## Appendix F – Road Safety Audit Designer’s Responses

# Adastral Park, Ipswich : Eastern Priority Junction Access off Ipswich Road

## Technical Note : Designer's Response to Road Safety Audits at Stage 1

**Stage 1 Road Safety Audit**

The Designers Response should be read in conjunction with the Road Safety Audit (ref SESL1718) as attached in Appendix A and revised Drawing No: 10391-HL-11C as attached in Appendix B.

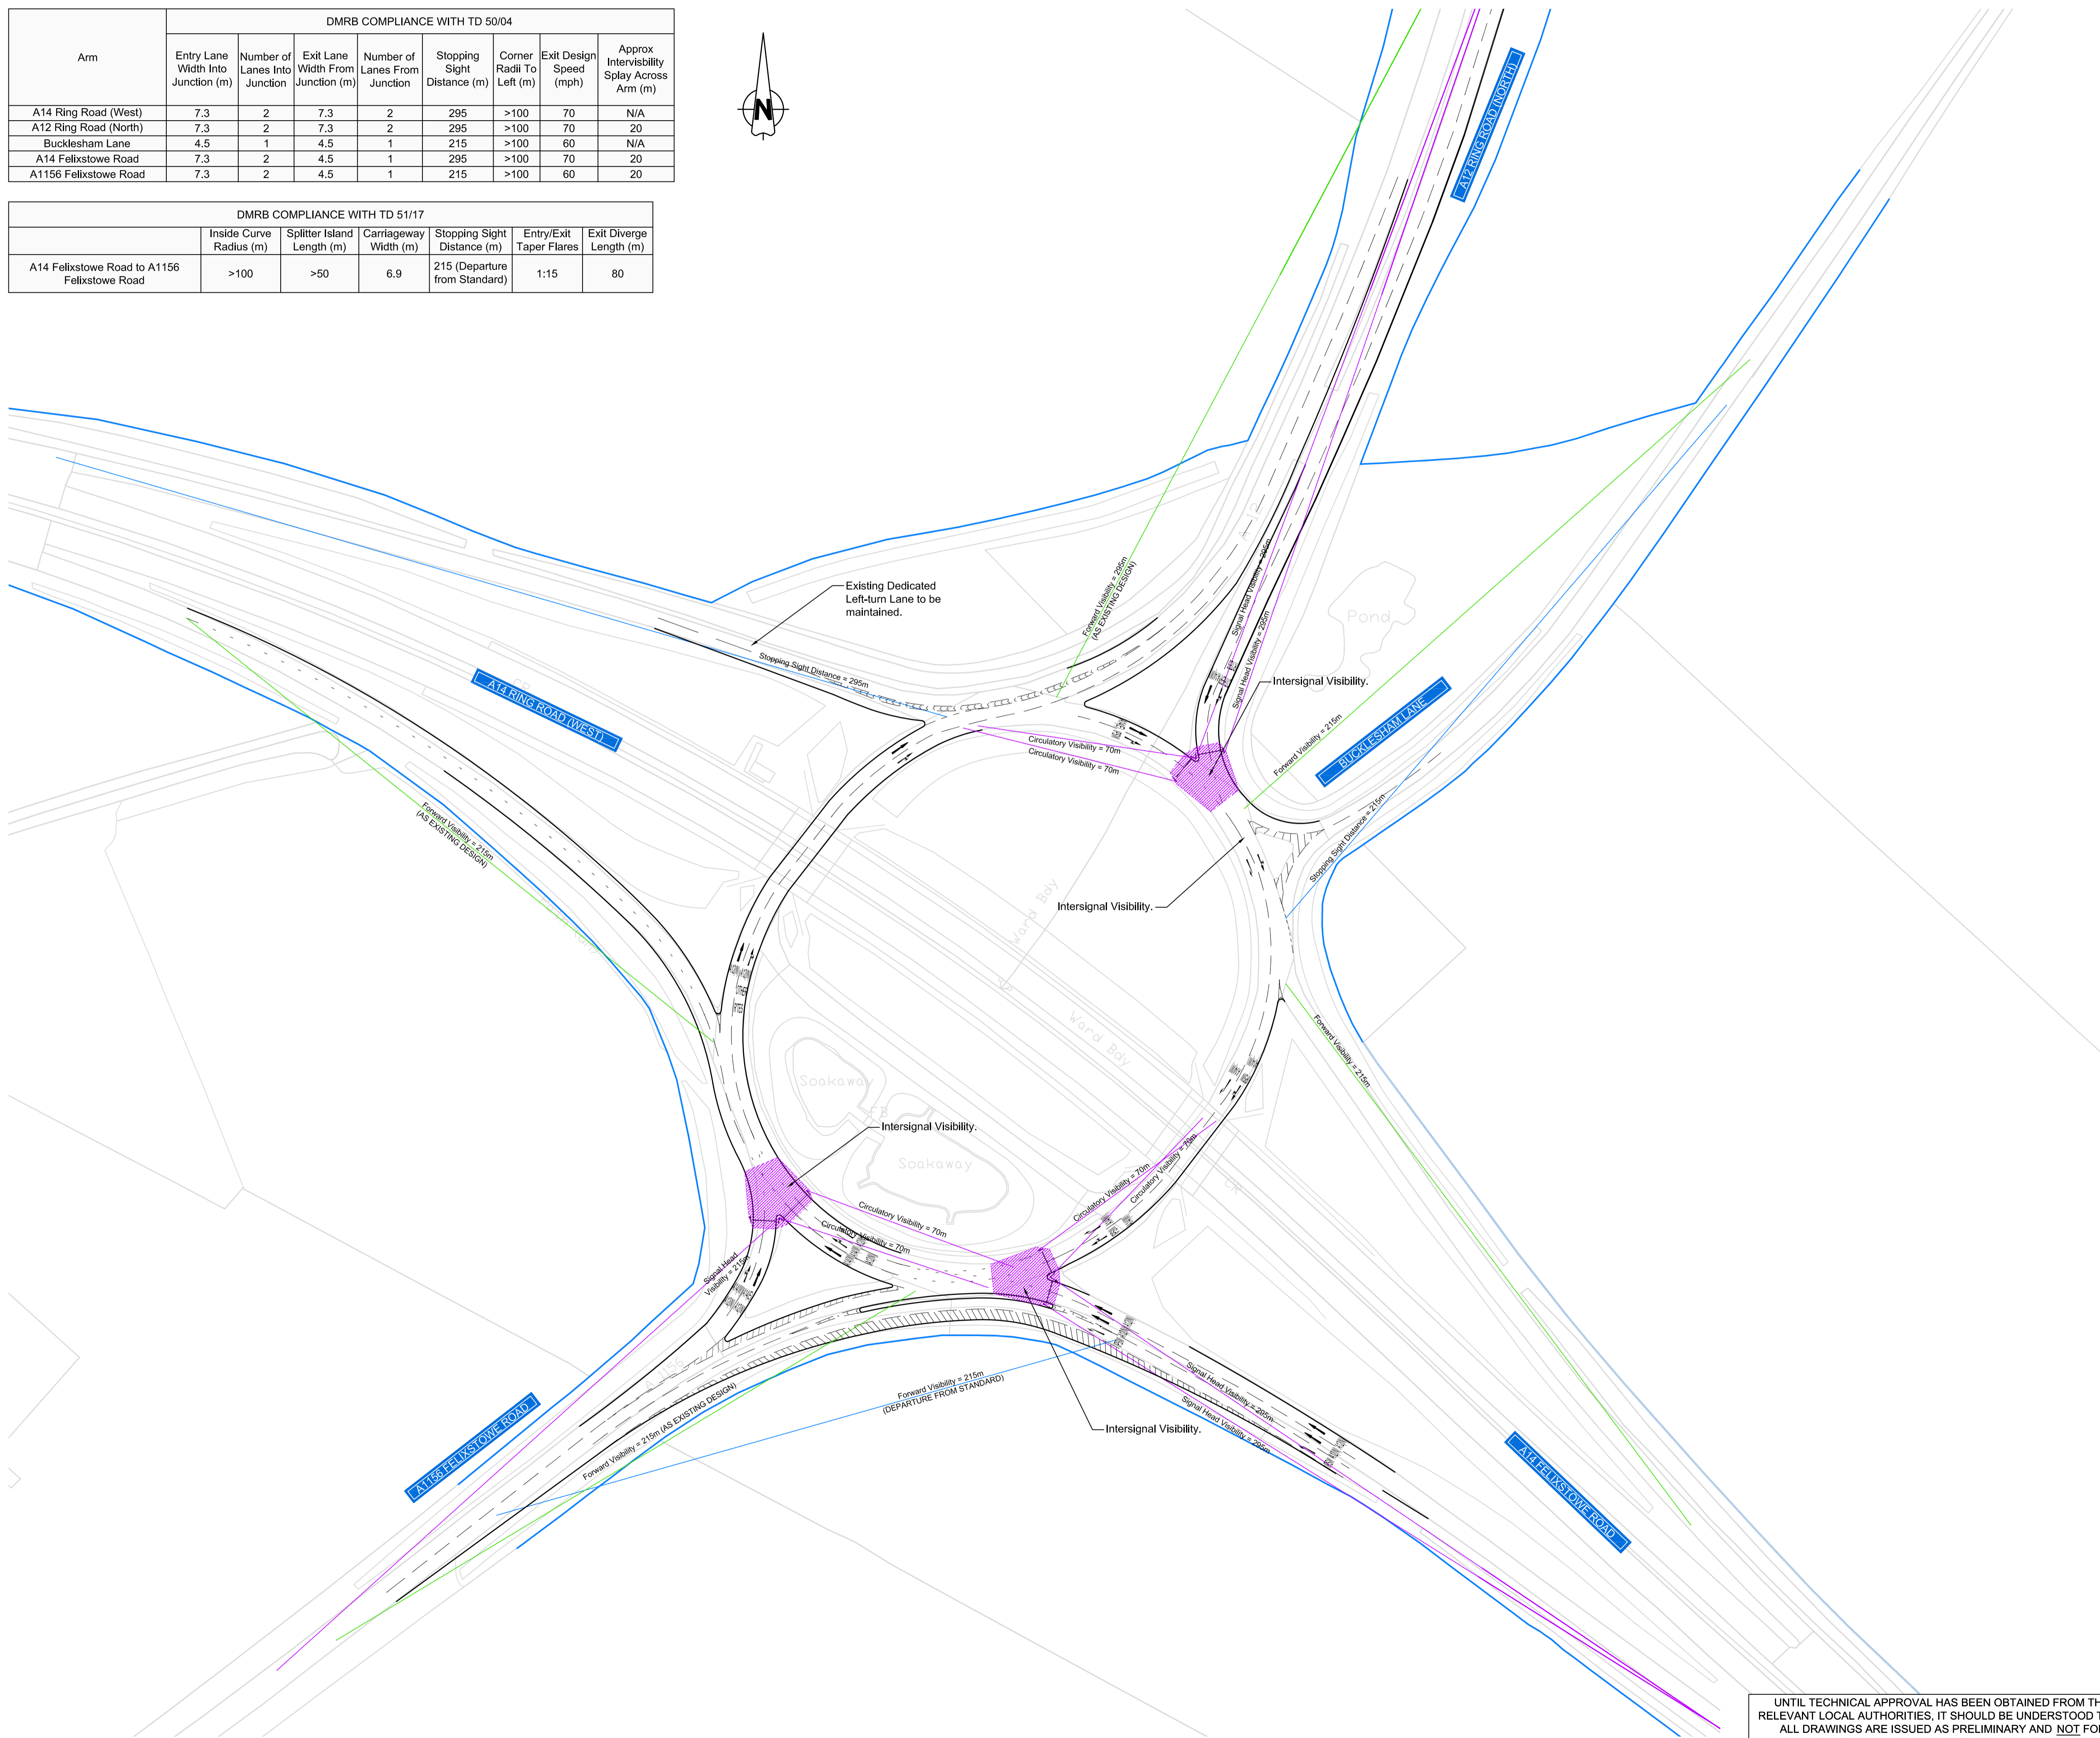
**Summary:** Risk of sideswipes and shunts (and non-compliance with stopline). The circulatory carriageway is reduced down to one lane on approach to the signals with the A12 entry. The hatching appears to create a pinch point for the two exit lanes to the A12 Ring Road which could lead to sideswipes. It also reduces stacking capacity at the signals which could result in queuing back into the offside exit lane, which if not anticipated could result in high speed shunts. (The layout also appears to show the stopline not extending from kerb to kerb, which means vehicles can legally cross the hatching against a red light).

**Recommendation:** Provide two lanes on this approach, removing the hatching.

**BCL Response:** *This has now been amended to reflect this observation.*

10391-H-0L-07 rev A	Proposed Western Signalised Access off A12 Dual Carriageway
---------------------	---

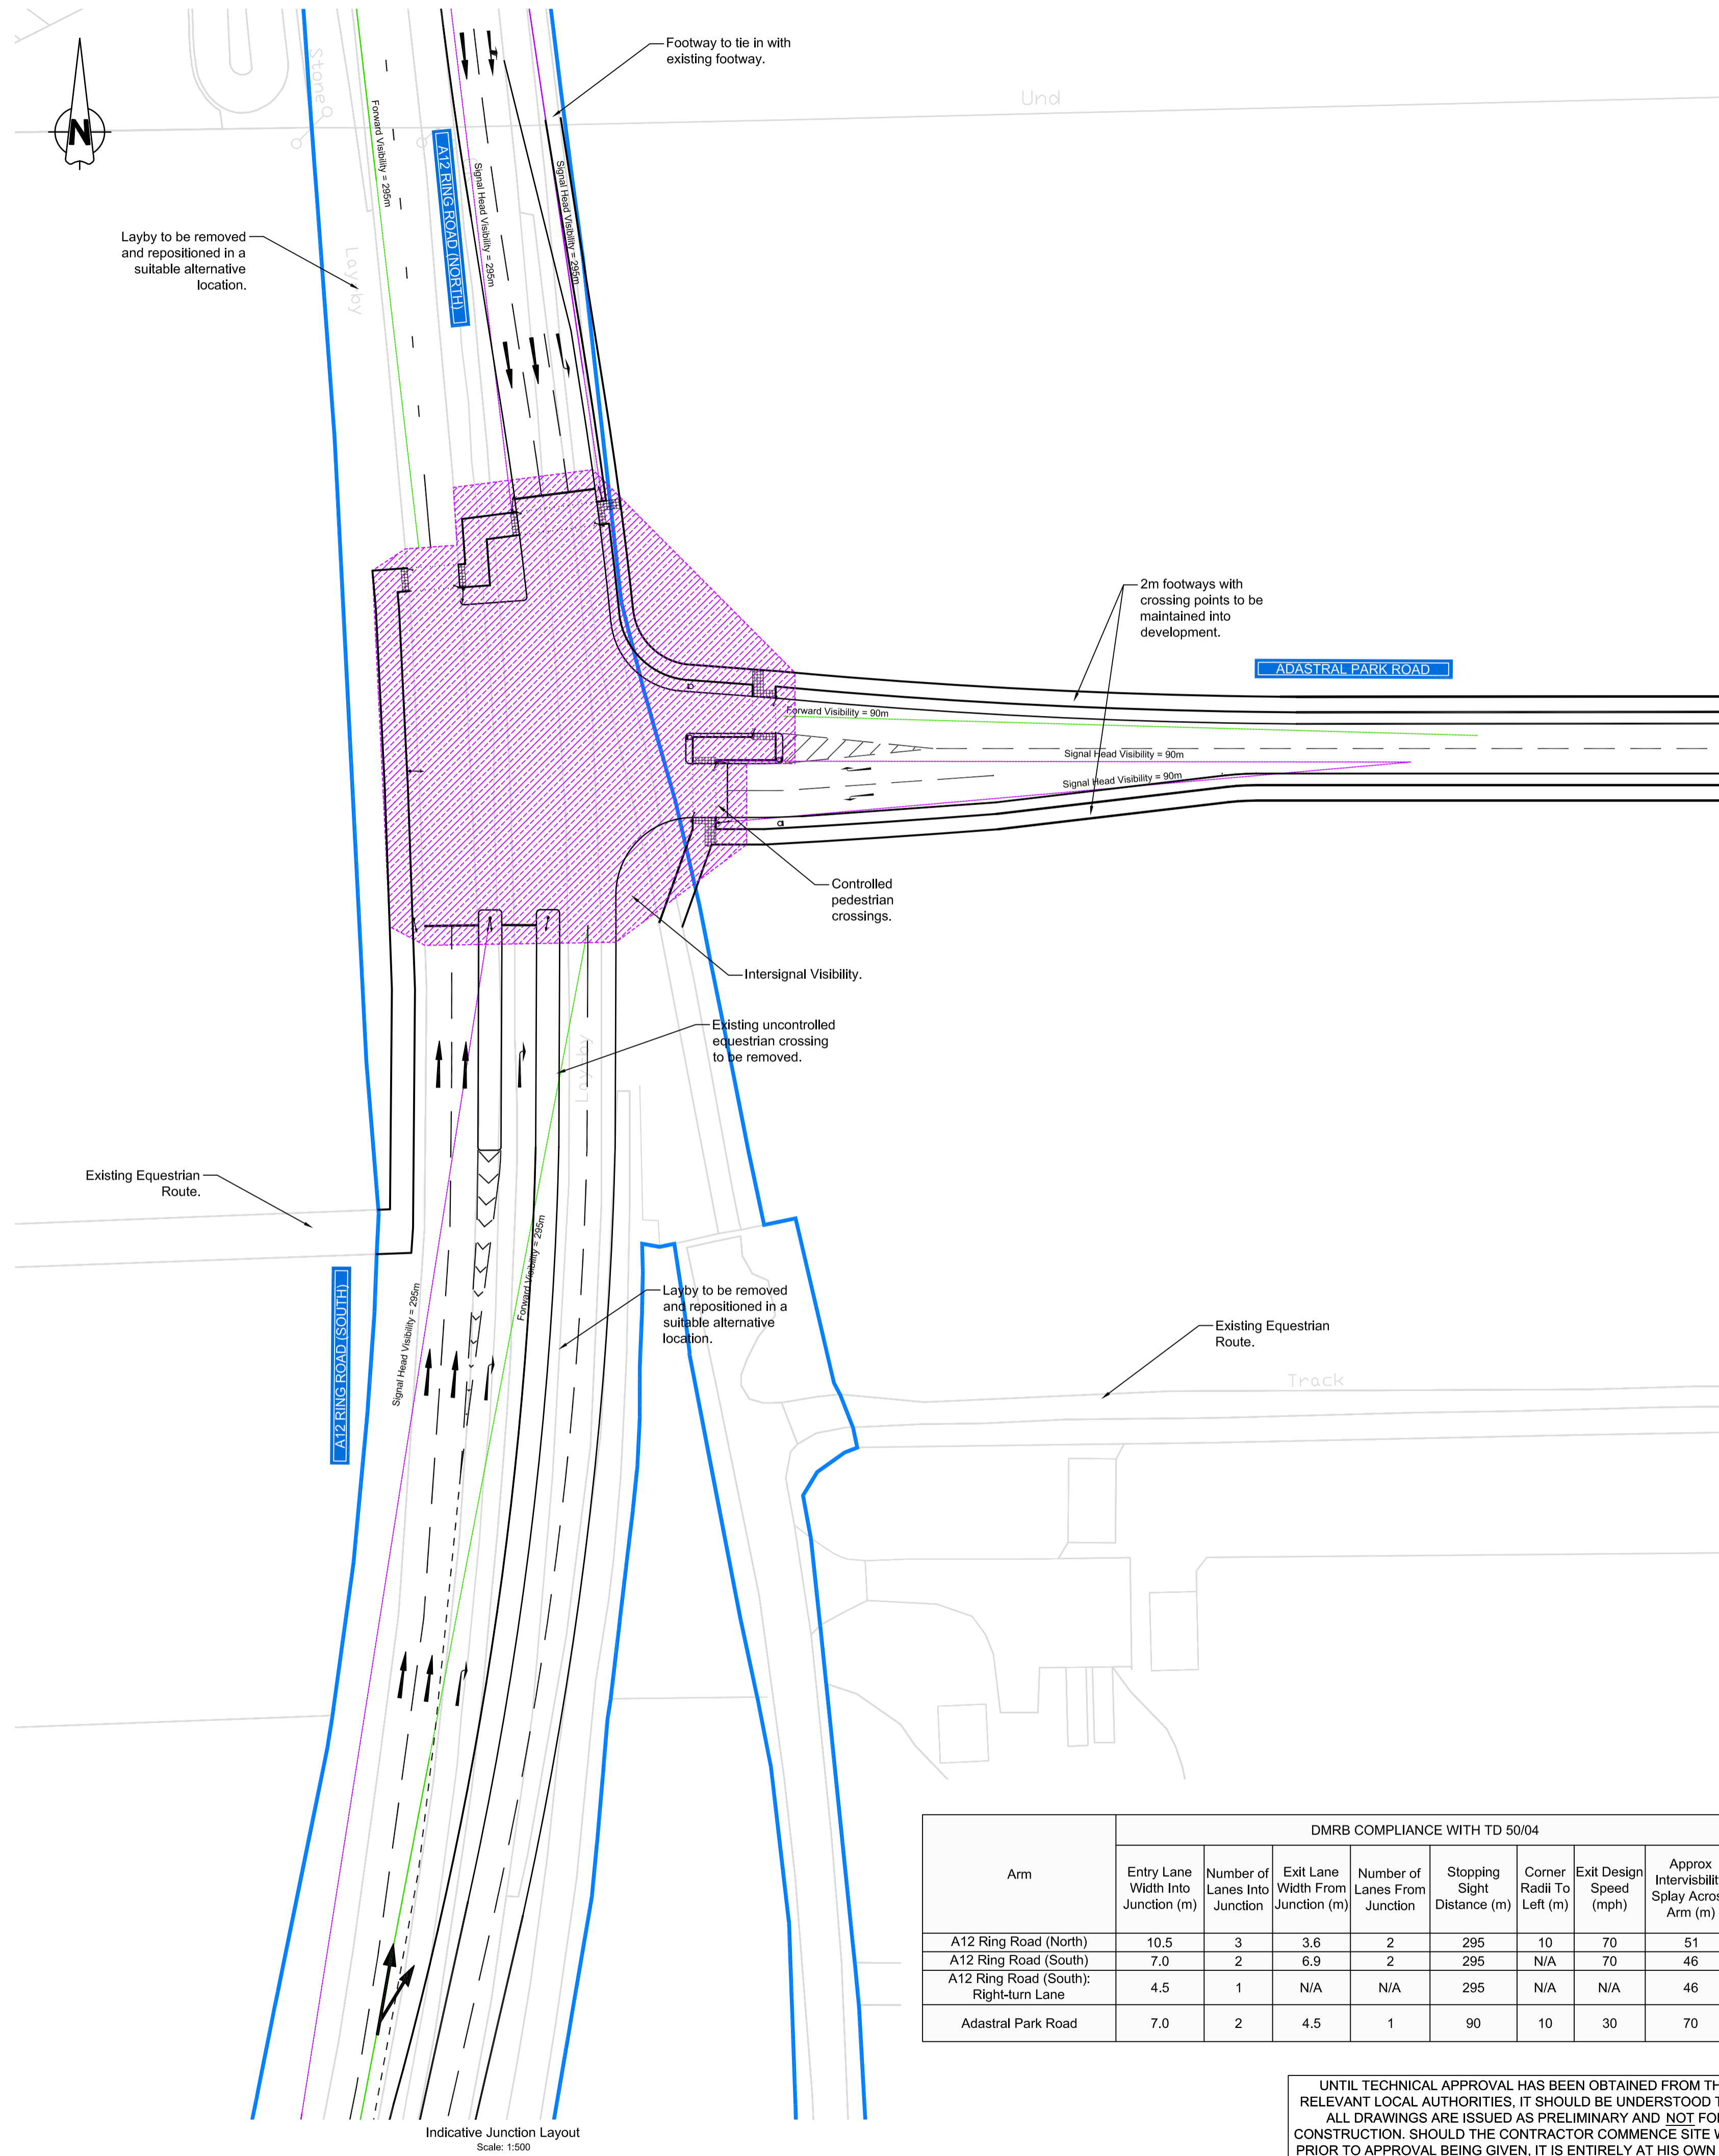
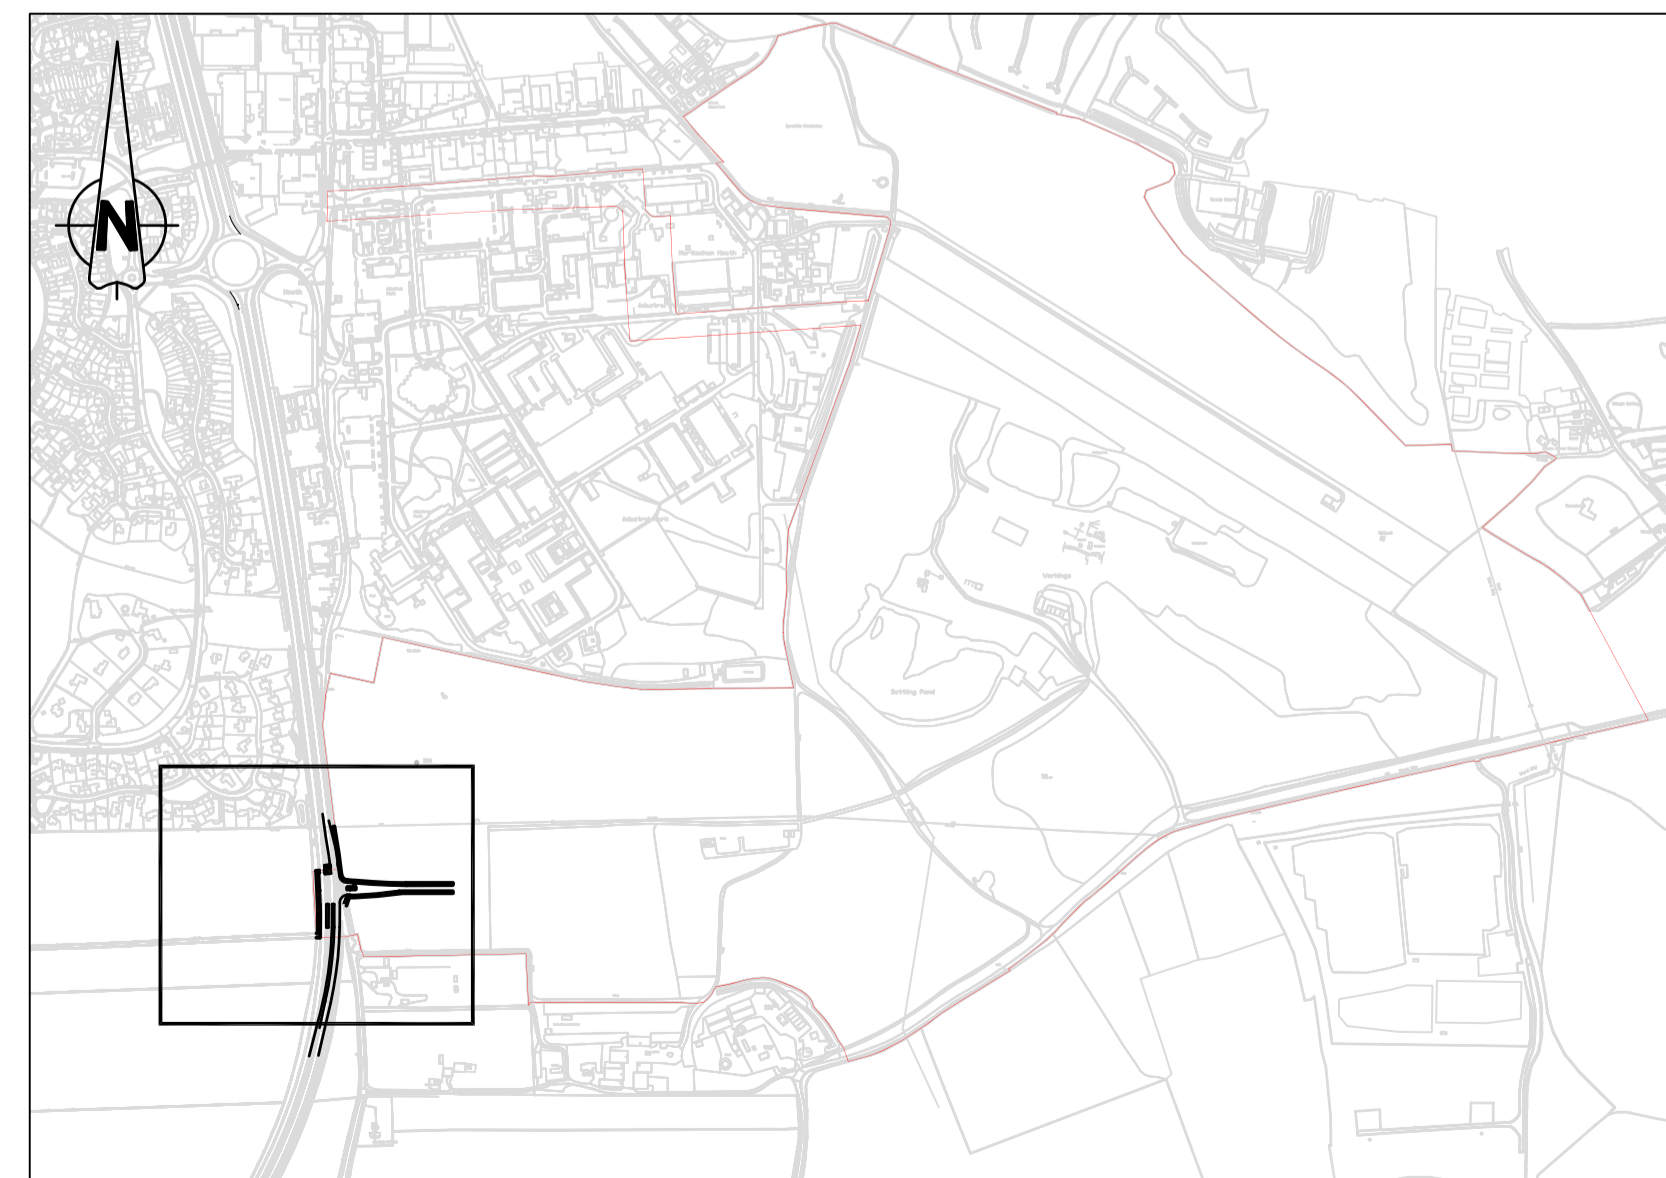
Problems 2.1 and 2.5 not identified on drawing.

C Modifications as per RSA comments. MDM LW PAB 07.09.17  
 B Modifications as per SCC's comments. MDM LW PAB 01.09.17  
 A Reflection of existing speed limits. MDM LW PAB 01.08.17  
 - First Issue - - - 21.06.17

Project Name: Foxhall Roundabout  
 Date: 11/11/2017  
 Scale: 1:1000  
 Drawing No: 10391-HL-40  
 Revision: A  
 Status: As Shown  
 Author: [Name]  
 Checker: [Name]  
 Approver: [Name]  
 Date: 11/11/2017

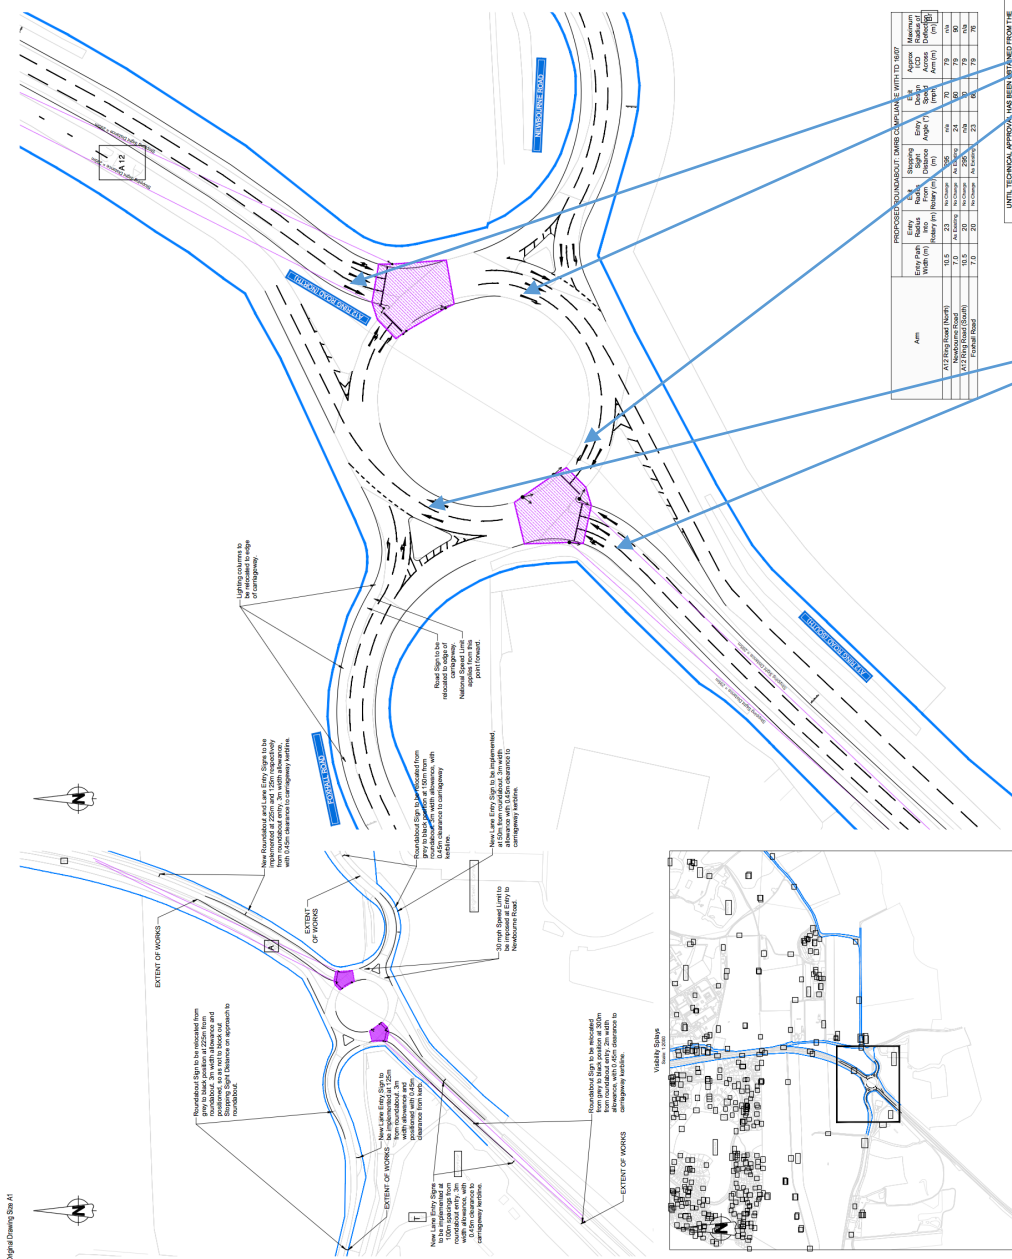
**Summary:** Confusing lane markings could result in lane change accidents. All 3 lanes are marked as ahead lanes. However, the offside ahead lane leads into a right turn only lane and as the default offside lane from the south and possibly also from the north (the tie-in is beyond the drawing extents) this is likely to result in lane changes on approach and also possibly last-minute on the circulatory carriageway itself when drivers are suddenly presented with a right turn arrow. In addition, this lane then becomes right turn only, effectively making it a U-turn lane which is likely to lead to sideswipe/lane change accidents at the Foxhall Road exit. See also Problem 2.2.

**Summary:** Risk of lane change accidents and/or sideswipes. There are 3 ahead lanes proposed for northbound vehicles, but these lead into two lanes on the circulatory carriageway.

**BCL response:** *The TSM Chapter 5 Para. 8.31 Recommends avoiding right turn arrows on the approach to the roundabout. The lining and directions can be amended during the detailed design of the junction in consultation with the Highway Authority with the appropriate advanced signing.*

**BCL Response:** *Agreed. The left hand lane should be shown as a left turn approach only (this has been done).*
